<b>AMENDMENT OF SOLICITATION/MODIFICATION OF CONTRACT</b>			1. CONTRACT ID CODE	PAGE 1 OF 1 PAGES
2. AMENDMENT/MODIFICATION NO 02	3. EFFECTIVE DATE 05/21/09	4. REQUISITION/PURCHASE RFO NO	5. PROJECT NO (if applicable)	
6. ISSUED BY National Aeronautics and Space Administration Ames Research Center Moffett Field, CA 94035-1000		7. ADMINISTERED BY (if other than Item 6)		
8. NAME AND ADDRESS OF CONTRACTOR (No Street county State and ZIP Code)			(4)	9A. AMENDMENT OF SOLICITATION NO NNA09273580R
			XX	9B. DATED (SEE ITEM 11) 05/08/09
				10A. MODIFICATION OF CONTRACT/ORDER NO.
				10B. DATED (SEE ITEM 13)
CODE	FACILITY CODE

Subj: Collaborative Support Facility, Building N232 at NASA Ames Research Center, Moffett Field, CA

Technical changes and/or alterations are hereby issued with this amendment.

N 232:  
Alternate  
Staging Area

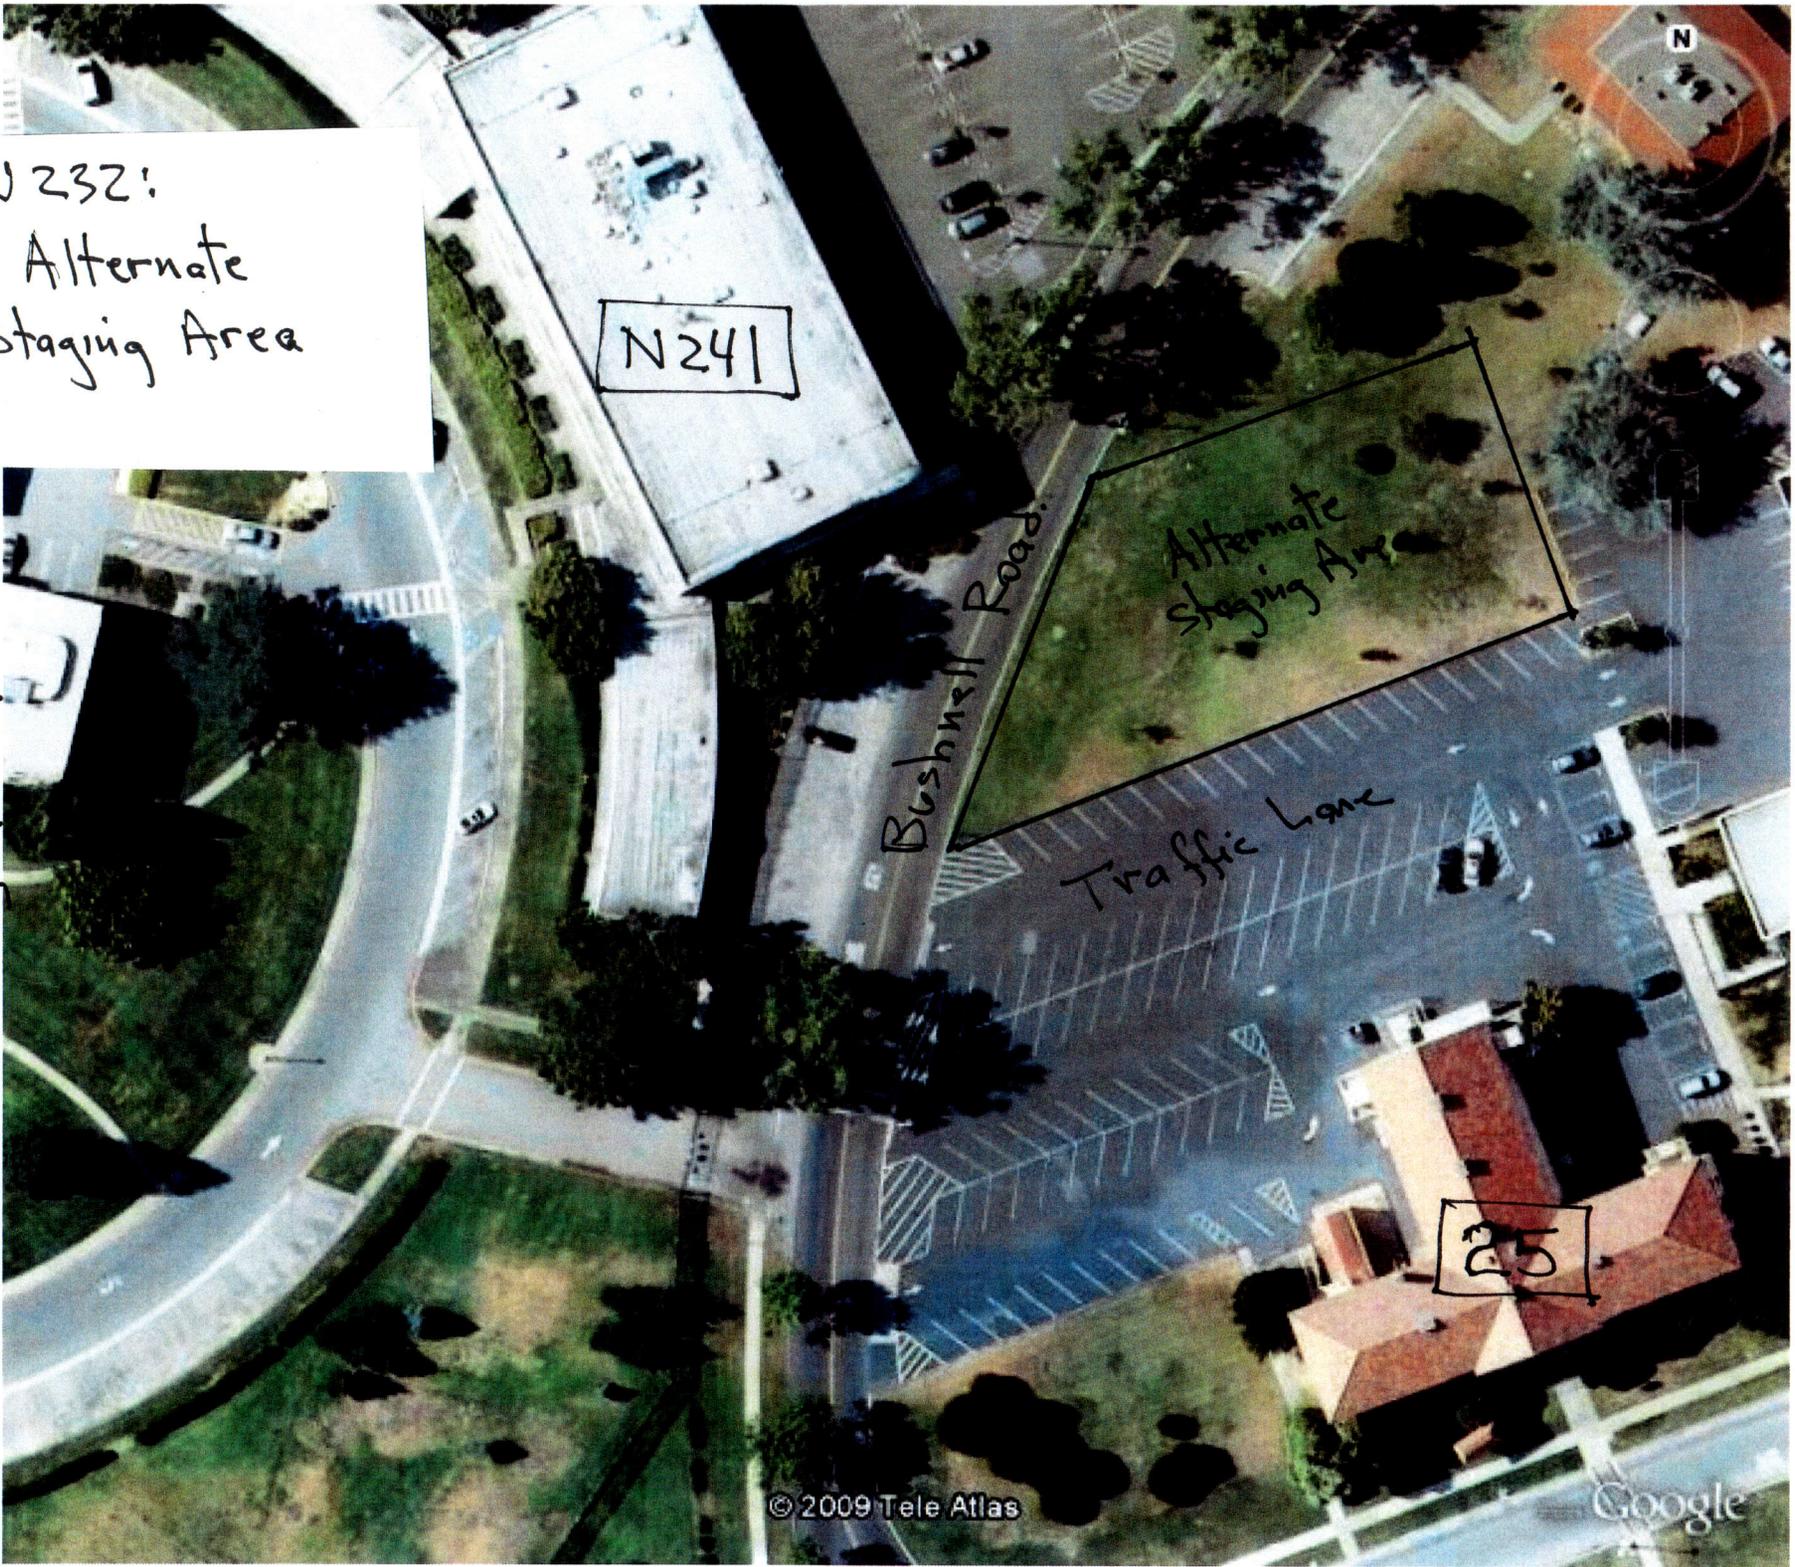
5. Refer to drawing A232-0800-C201, titled Site Plan, and to the attached areal view titled "Alternate Staging Area." The attached sketch identifies a grassed area north of Building 25, bordering on Bushnell Road. This area can be used by the Contractor for a laydown area for equipment and materials. At the end of use, this area must be restored to its pre-use condition; landscaping and irrigation system must be restored. The adjacent paved area must be kept clear for through traffic and traffic controls on Bushnell Road must be established and maintained by the Contractor.
